UNITED STATES PATENT AND TRADEMARK OFFICE

Office Action Summary

10/538,082

DETAILED ACTION

FIG. 7

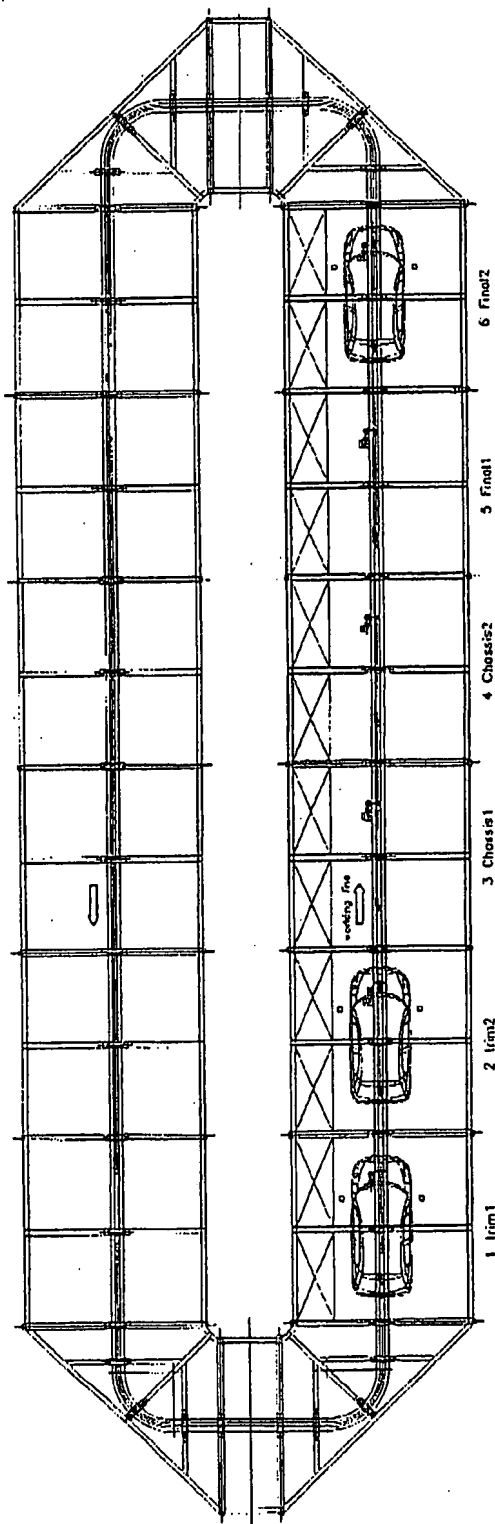
new Figures 7, 8a, 8b, 9, 10, 11a, 11b, 12a, 12b, 13a, 13b, 13c, 14a, 14b, and 14c all constitute new matter not supported by the original disclosure.

For example, with respect to new Figure 7, the specification as originally filed does not support the showing of a conveyor that is laid out/shaped as shown in Figure 7, nor does it support the showing of the specific stations labeled thereon, nor the showing of such in the order set forth in Figure 7, for example.

Not approved
EEC
8/1/07

Applicant is required to cancel the new matter in the reply to this Office Action.

FIG. 8b

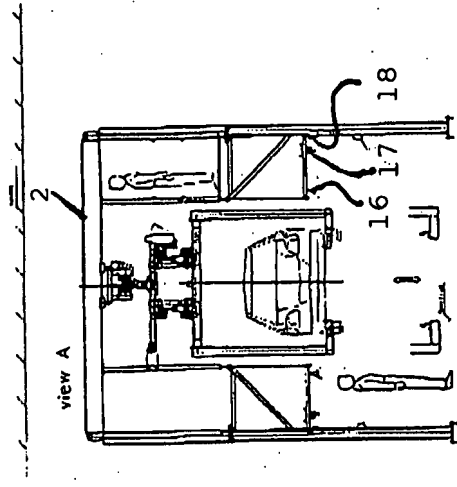
A similar situation exists for each of the newly-added figures. For example, it is noted that the specification as originally filed does not support the level of detail shown in Figures 8a and 8b, the particular configuration of "driven element" acting on a tire shown in new Figure 9, nor even the particular configuration of the tire shown in Figure 9, the particular configuration of the "motor-driven element" acting on a "wheel rim", nor the particular configuration of "wheel

Not
Approved
ECC
8/1/07

FIG. 9

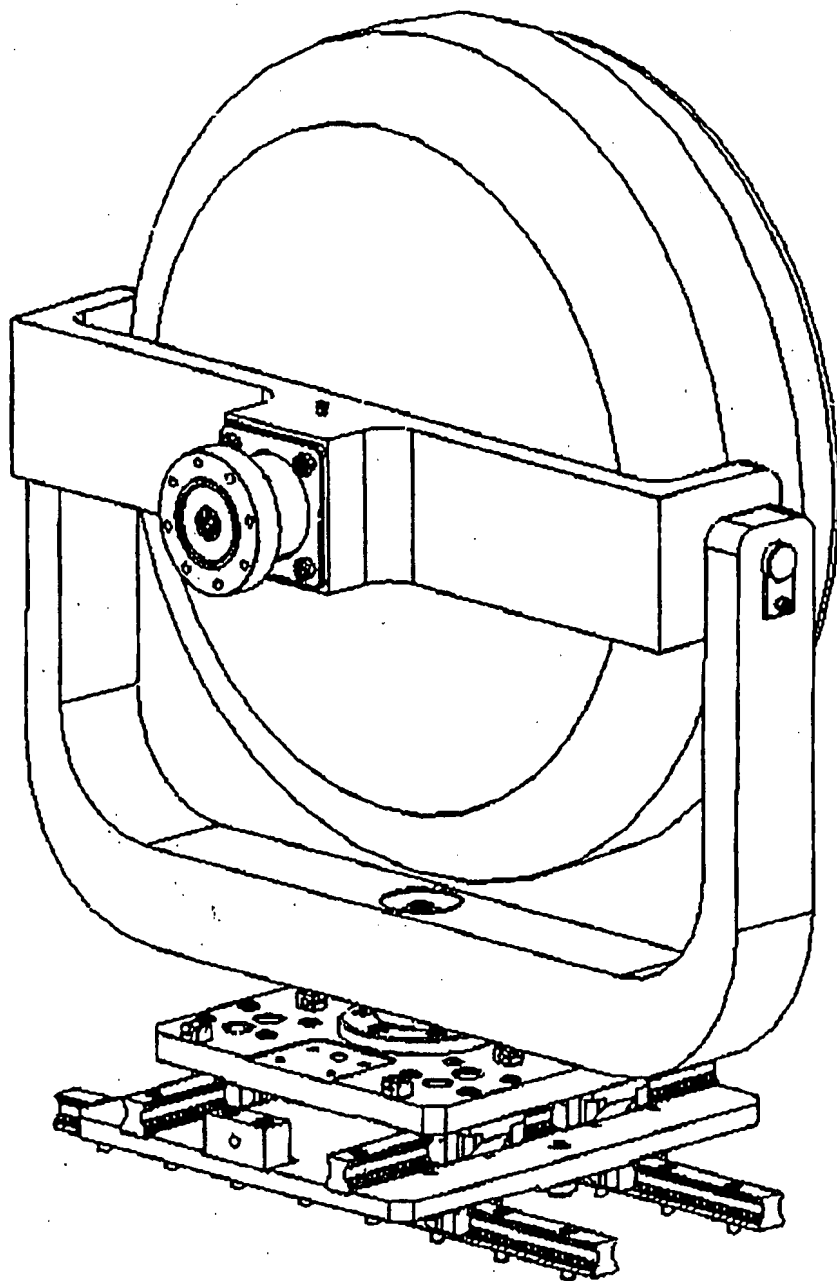
Not approved

FIG. 10

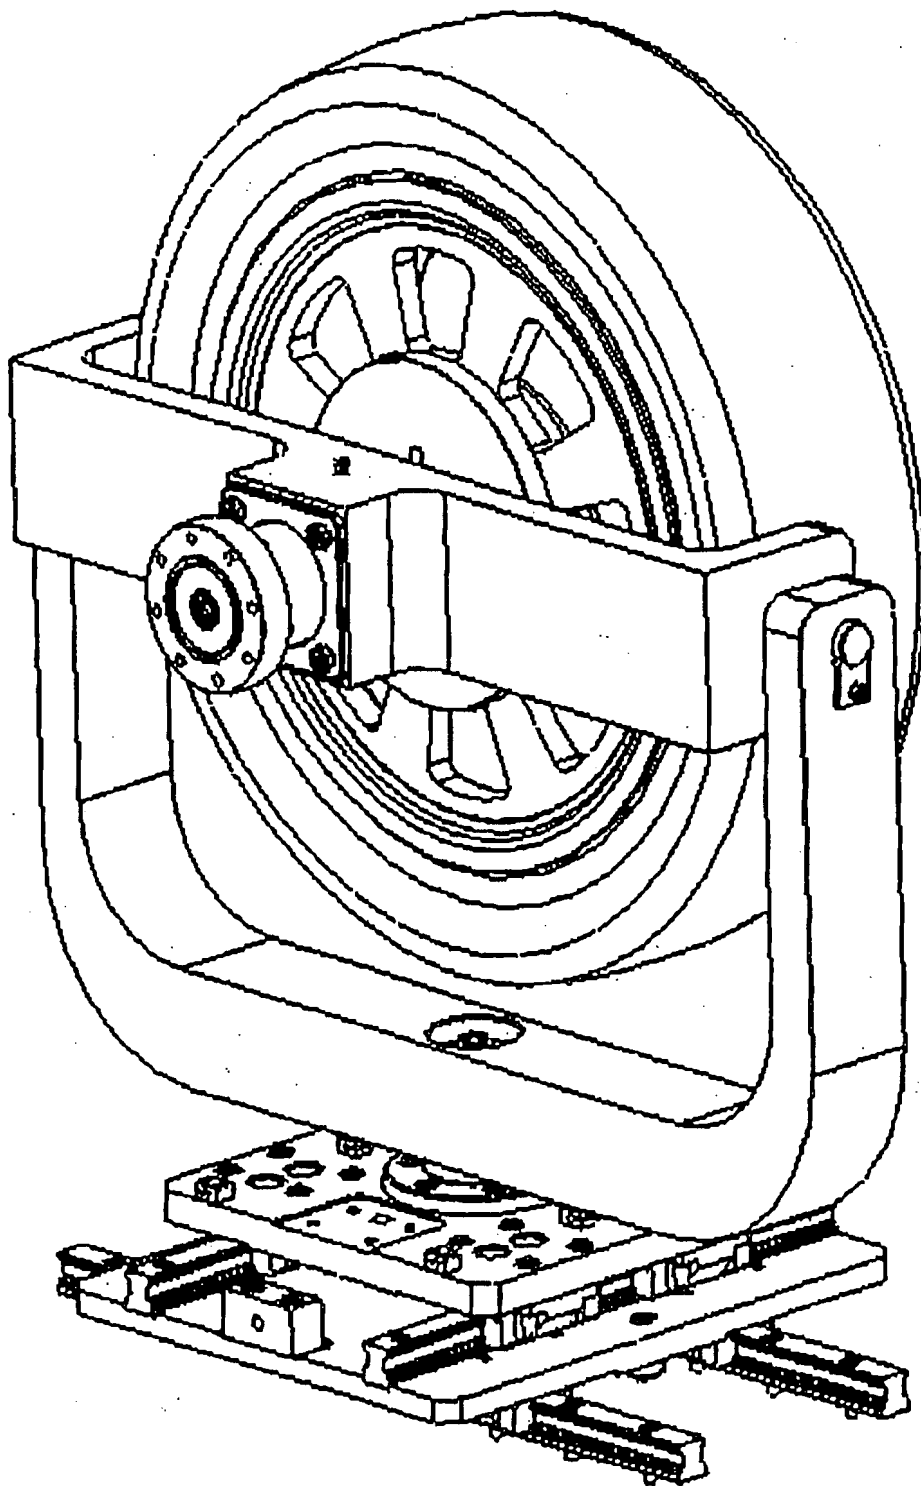
rim” shown in Figure 10, the particular configuration of “motor driven element” acting on a “wheel hub” shown in new Figure 11a, nor the particular configuration of “wheel hub” shown in new Figure 11a, the configuration of “motor vehicle element” shown in new Figure 11b, the particular configuration of a “means for automatically performing accelerating and braking operations” shown in new Figure 12a and 12b, nor the particular configuration of “tire” shown in new Figure 12a, the particular configuration of the “means for overhead conveyance” shown in new Figures 13a-13c (particularly noting that the configuration shown in new Figures 13a-c is of a different configuration than the overhead conveyance arrangement shown in the original figures, see at least original figures 2b and 3b, for example), and the particular configuration of “modular components that perform assembly” shown in new Figures 14a-14c.

Not Approved
EEC
8/1/07

FIG 11a

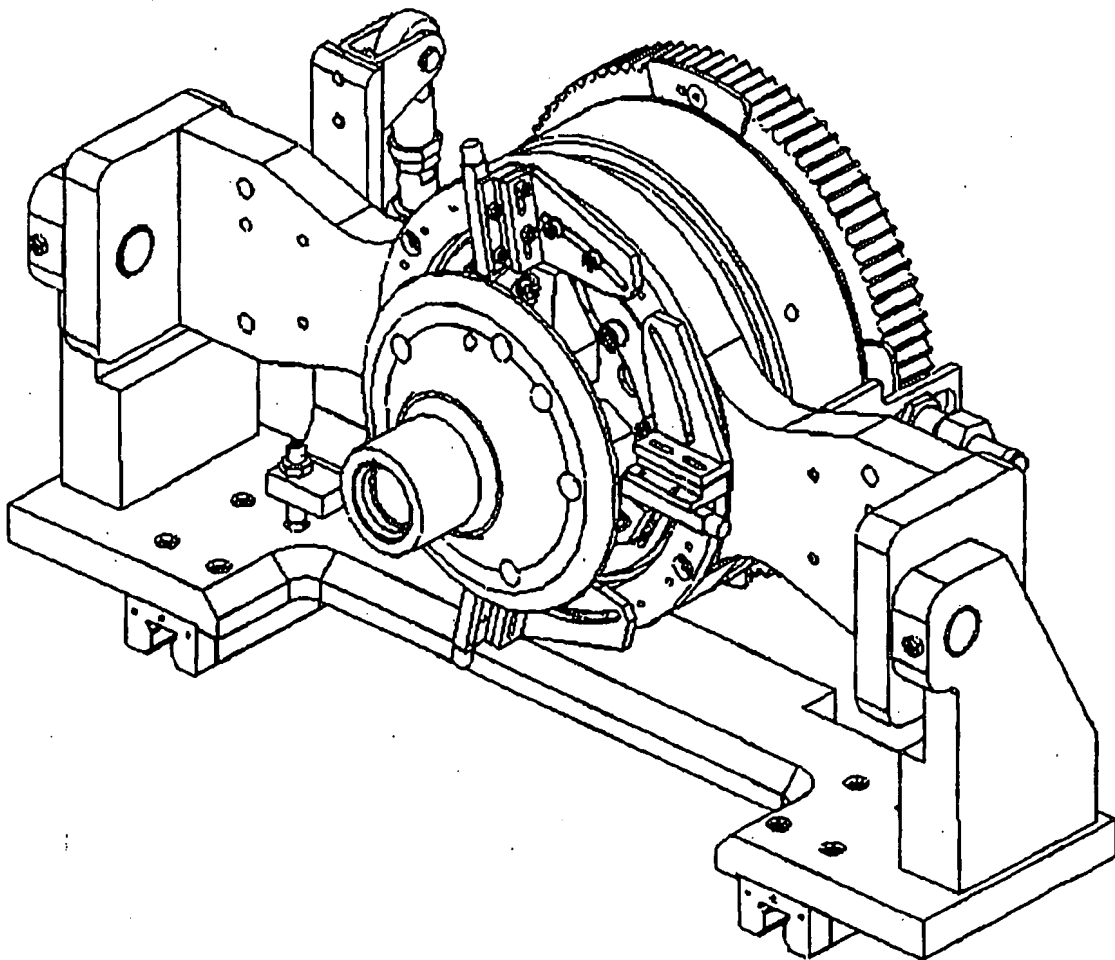
Not Approved
8/1/07
GCL

FIG. 11b

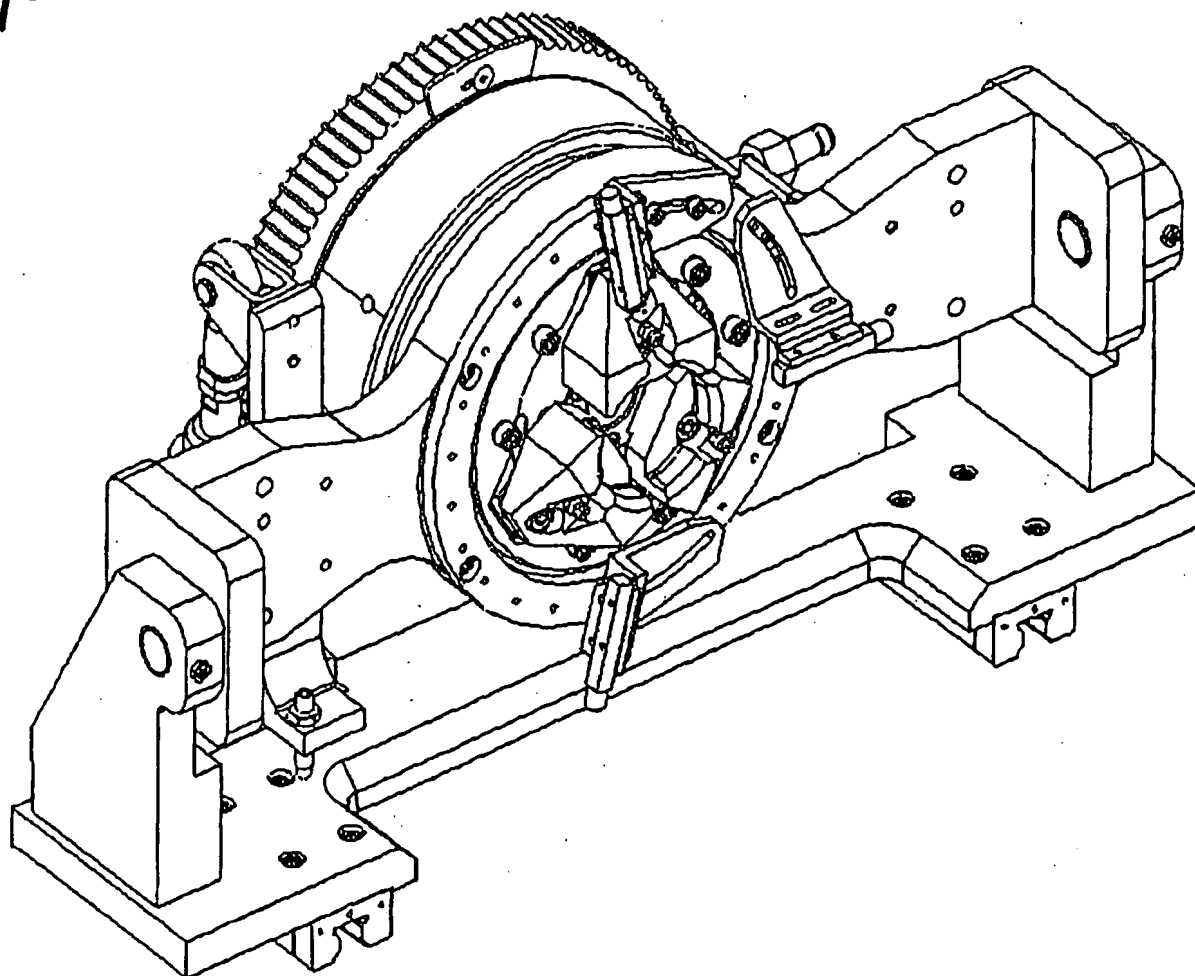
Not
approved
EEC
8/1/07

FIG. 12a

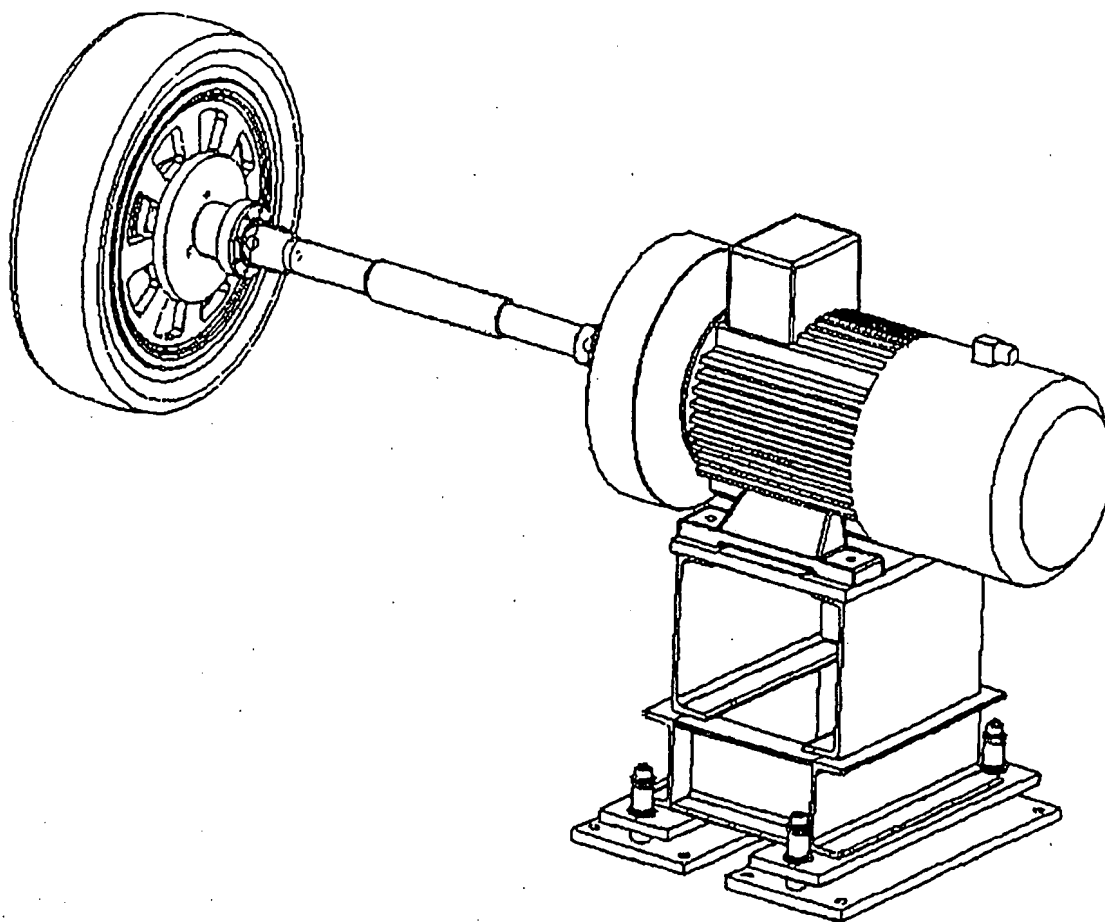
Not Approved
SEC
8/1/07

FIG. 12b

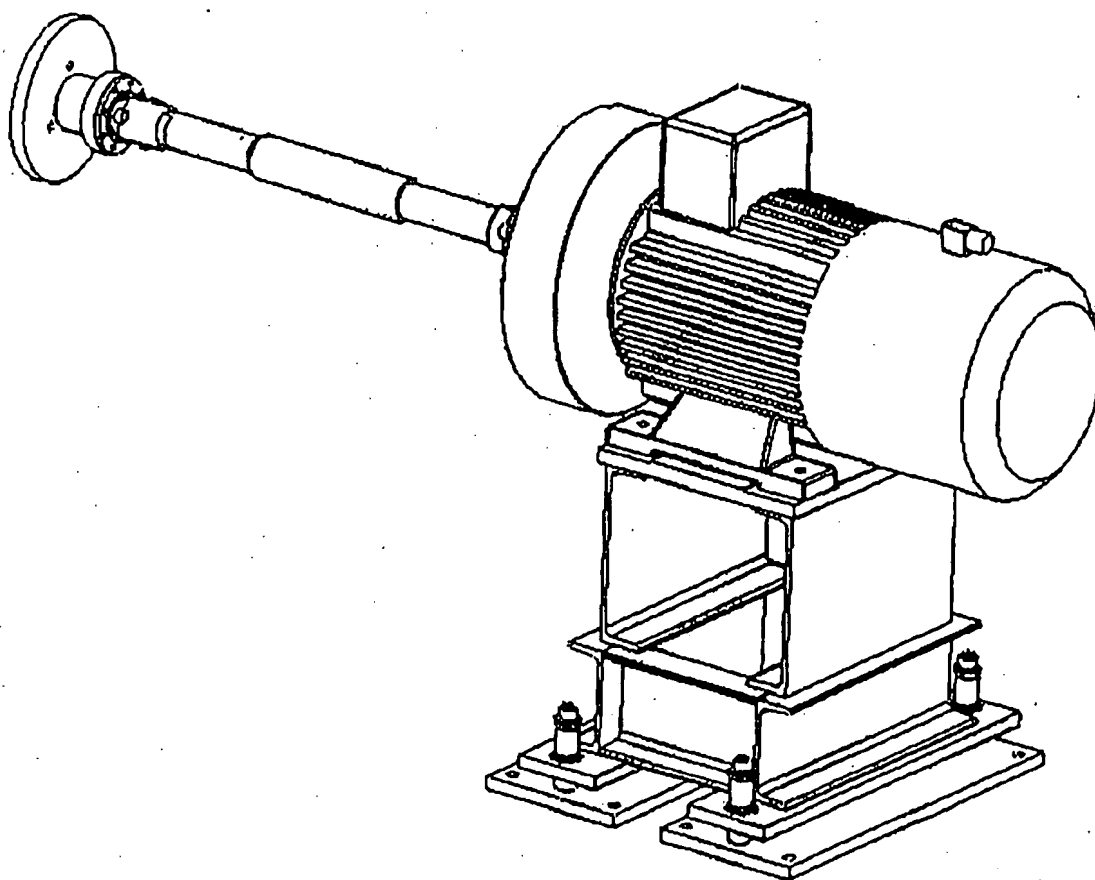
Not Approved
8/1/07
GEC

FIG. 13a

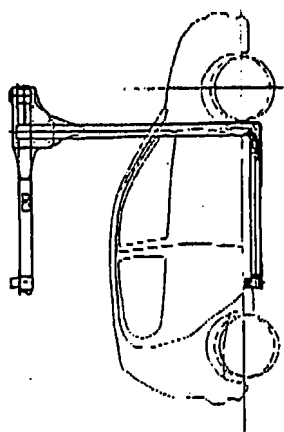
Not Approved
EEC
8/1/07

FIG. 14b

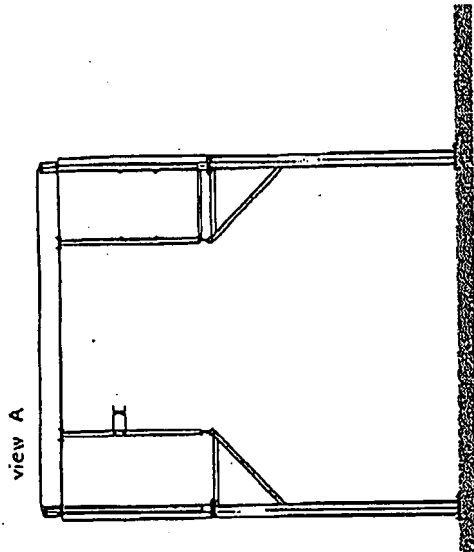
Not approved
EEC
8/1/07
